**WRITTEN STATEMENT OF CONDITIONS**

The City of North Richland Hills received this plat on August 19, 2020. The Development Review Committee reviewed this plat on September 1, 2020. The following represents the written statement of the conditions for conditional approval of the plat.

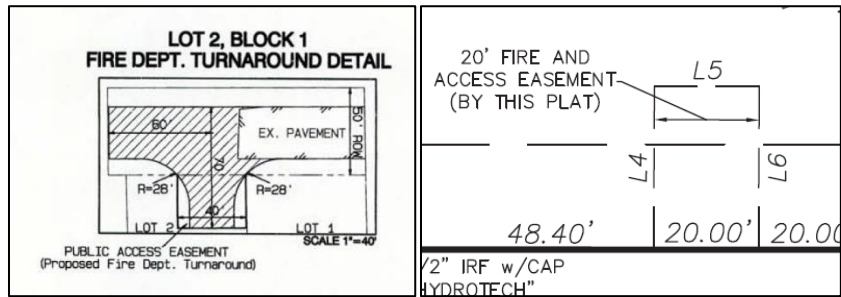
6. In the area shown below, clarify the line work. It is unclear what some lines are intended to reference. *NRH Subdivision Regulations §110-333 (Additional requirements for plat drawings)*
